UNITED STATES PATENT AND TRADEMARK OFFICE

APPLICATION NO.	FILING DATE	FIRST NAMED INVENTOR	ATTORNEY DOCKET NO.	CONFIRMATION NO
09/764,943	01/18/2001	Mathieu Tallegas	40535/JEC/X2	6947
35114	7590 06/24/2004		EXAM	INER
ALCATEL INTERNETWORKING, INC. ALCATEL-INTELLECTUAL PROPERTY DEPARTMENT 3400 W. PLANO PARKWAY, MS LEGL2			GEREZGIHER, YEMANE M	
			ART UNIT	PAPER NUMBER
PLANO, TX	The state of the s		2144	
			DATE MAILED: 06/24/2004	1

DETAILED ACTION

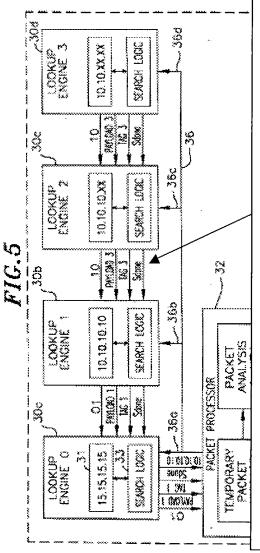
- 3. The drawings are objected to because Fig. 5 contains minor errors (See Fig. 5 below). Corrected drawing sheets are required in reply to the Office action to avoid abandonment of the application. Any amended replacement drawing sheet should include all of the figures appearing on the immediate prior version of the sheet, even if only one figure is being amended. The figure or figure number of an amended drawing should not be labeled as "amended." If a drawing figure is to be canceled, the appropriate figure must be removed from the replacement sheet, and where necessary, the remaining figures must be renumbered and appropriate changes made to the brief description of the several views of the drawings for consistency. Additional replacement

According to the claimed invention, there is a minor problem in this Figure. Engine 3 transmits its result to engine 2, engine 2 generates its own result and comparison is made to select the best match from the two generated results. The inventive entity recites, "In an alternative embodiment, if a later lookup engine has a better match than an earlier lookup engine, the later lookup engine payload, match quality, and tag are validated and used. Lookup engine 2 also transmits to lookup engine 1 a search done signal." Further discloses, "If lookup engine 1 did not have a better match, it would have used lookup engine 2's payload. match quality, and tag." (See Specification Page 10, Lines 8-12 and 20-22. According to the claimed invention, the stack of lookup engines pass the best match from top lookup engine to the bottom lookup engine. According to the drawing, the result of engine 2 is better in terms of quality (longest matching prefix). Therefore, since the result of lookup engine 2 is better (longer prefix), engine 2 should pass the payload 2. tag 2 to lookup engine number 1. Appropriate correction is required.
